# Idaho Falls Events Center: Meeting Minutes – SD Architectural Update Meeting

Date: August 27<sup>th</sup>, 2012

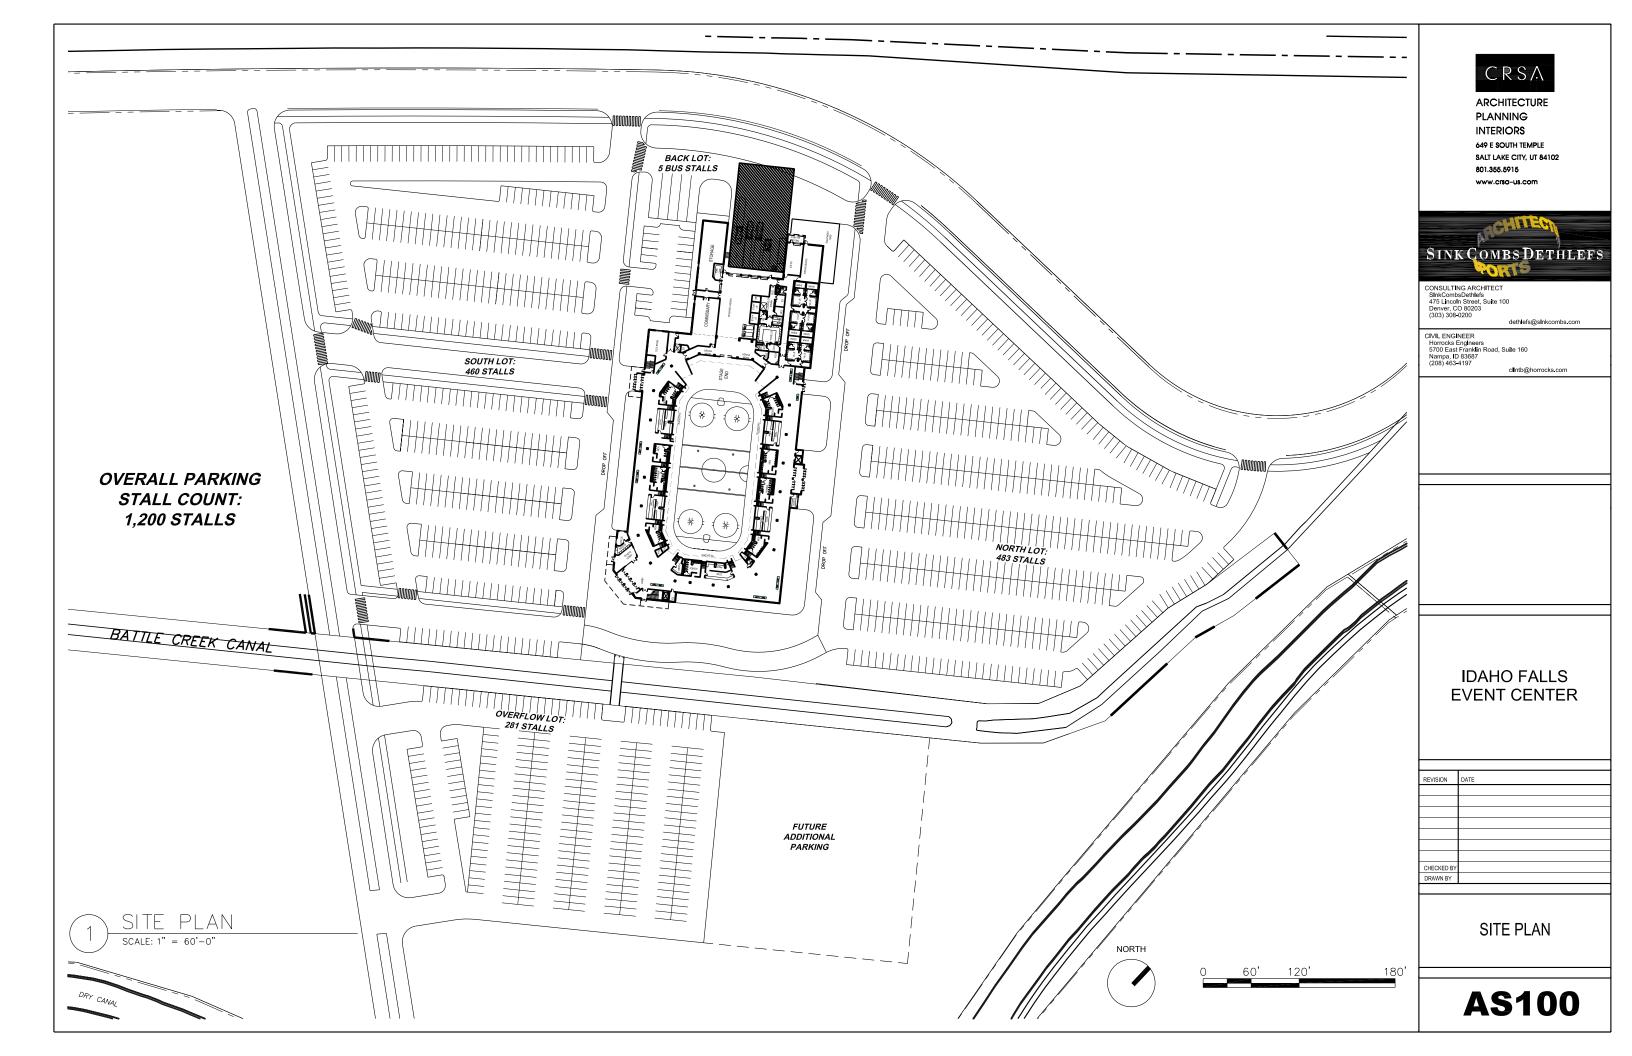
- a. Basic 'U' Shaped lobby area with main entrance access from northwest parking area.
- b. (5) Five Meeting spaces for up to 300 people in a dining setting. Larger if large meeting.
- c. Entrance discussions from Commissary. Showing right now only one entrance into larger meeting space in middle. Could have more doors into other areas.
- d. Storage spaces on either side could be removed for more access from commissary.
- e. Access to the restrooms other side can be locked if using only meeting area.
- f. Increase size of Alternate towards west. Add more seating perhaps being bigger it has better perception that the space is not competing with hotel spaces.

SCD – To change the size of Alternate to align two walls and allow more seating.
